# UNITED STATES PATENT AND TRADEMARK OFFICE

APPLICATION NO.	FILING DATE	FIRST NAMED INVENTOR	ATTORNEY DOCKET NO.	CONFIRMATION NO.
10/816,192	04/02/2004	Gi-joong Jeong	Q80883	7520

**Office Action Summary**

**DETAILED ACTION**

**Figure 2, Annotated**  
**From Vardon (2002/0190620)**

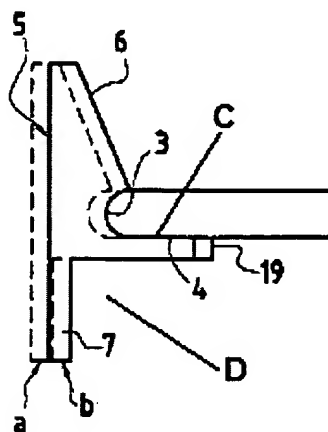
5. Vardon, however, teaches a refrigerator shelf comprising a horizontal glass (1); a glass supporter (2) coupled to edges of the glass, said glass supporter comprising a first side surface and second side surface (Item C in Figure 2 Annotated); a first coupling portion and a second

coupling portion (7), forming first and second cavities (Item D in Figure 2 Annotated), respectively, and extending downward from, respectively, the first and second side surfaces (C); first and second brackets (12) coupled, respectively, to the first and second coupling portions of the glass supporter, and capable of being attached onto a wall of the storage compartment; wherein the first side surface (C) of the glass supporter and an exterior side surface (i.e., the upper edge of Item 18) of the first bracket form a substantially flush exterior side surface; wherein the glass supporter (2) is disposed between the first and the second brackets (12).

6. The examiner points out that Item 18 is described as "[following] the contours of the supporting surface" (see paragraph 43, lines 18-23); and that this can be interpreted to mean Item 18 extends the entire length of thickness (19). Such a configuration of Item 18 would obviously leave the upper edge of Item 18 flush with the first side surface (C). The examiner also points out that at least a portion of the glass supporter (2) is disposed between the first and the second brackets (12).

**Figure 1, Annotated  
From Vardon (2002/0190620)**

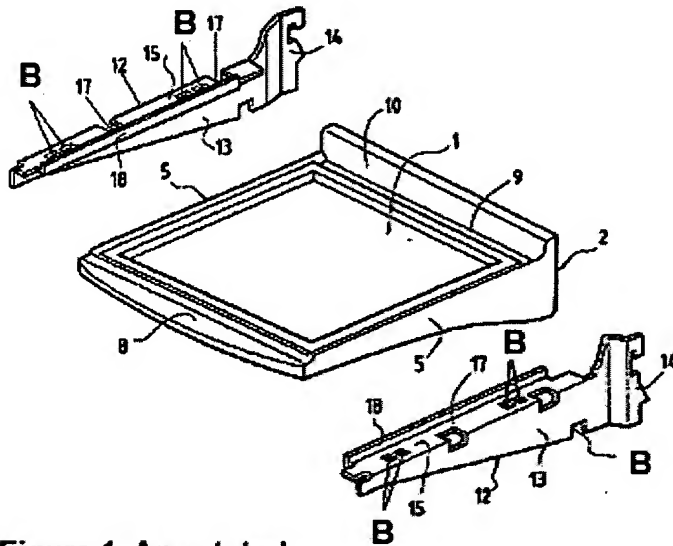
9. Lye and Vardon teach the structure substantially as claimed, including a refrigerator shelf comprising a glass (1) on which foodstuffs obviously can be laid; a glass supporter (2) coupled to edges of the glass, said glass supporter comprising a main portion (6) coupled to (3) the edges of the glass, and a first coupling portion and a second coupling portion (7 - aka "bracket supporters"), forming first and second cavities (Item D in Figure 2 Annotated), and each extended downward at opposite sides of the main portion (see Figure 3) and supported with the supporting bracket (see paragraph 43); first and second brackets (12 - aka "a pair of brackets")

**Figure 3, Annotated  
From Vardon (2002/0190620)**

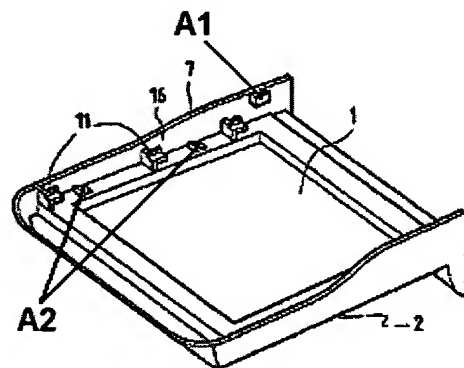
provided in opposite sides of the glass supporter and supported onto a wall of the storage compartment (see paragraph 43); couplers (Item A1 & A2 - see Figure 3, Annotated) oriented horizontally, disposed inside the first and second cavities (D), and coupling a lower part (7) of the glass supporter with the bracket; holes (Item B – see Figure 1, Annotated) corresponding to each coupler, said couplers and holes comprising “coupling units”; and a plurality of supporting ribs (11) formed, between the couplers, within the cavities (D), with each supporting bracket (12) provided with a bending portion (15) fitted to the supporting ribs (11) via grooves (17 - aka “notches”).

10. The examiner points out that the horizontally-oriented coupler (A1) is stated as being equivalent (see paragraph 43, lines 1-5) to the vertically-oriented coupler (A2); as such, Vardon can be said to teach both horizontal and vertical orientations for the couplers. Additionally, Maruta is viewed as teaching merely the use of coupling units comprising coupling bosses, penetrating holes, and couplers, and not necessarily any particular orientation of such coupling units. Therefore, replacing the couplers (A) of Vardon with those taught by Maruta would provide a structure wherein “the coupler comprises a plurality of screws horizontally penetrated into the plurality of penetrating holes and accommodated in the plurality of coupling bosses”.
